Product hierarchy no. *				Part no.	SBU	Type / Description	Customer part no.
SBU	PG	PGU	Type				
02	005	016	0000001209	See list below		6765 Power Entry Modul

2 Type of change

Product Change Notification					PCN 6765		D10-039-936
owner	creation date	release date	released by	change order no	rev	page	
huberth	24.09.2019	01.10.2019	limachcl	2018409	A	1 of 1

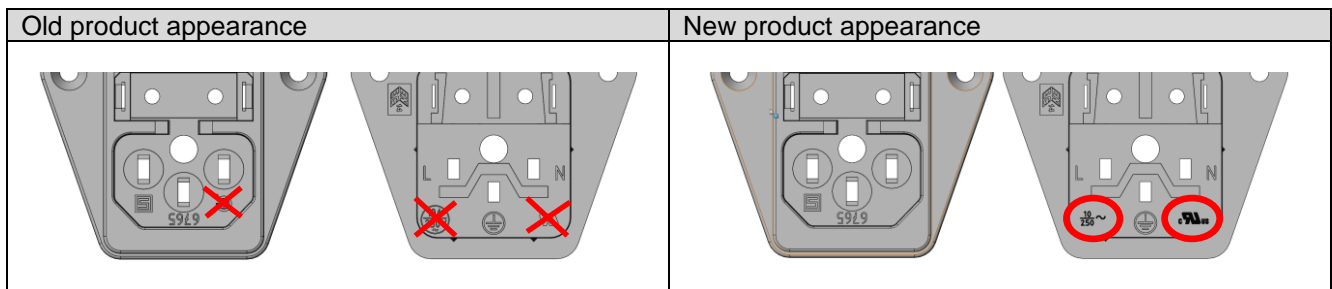
Change of approval markings from UR and CSA to the combined cURus on the product socket.

Form	Yes	Socket new with cURus approval marking
Fit	No	-
Function	No	-
Manufacturing	No	-
Label	No	-
Packaging	No	-
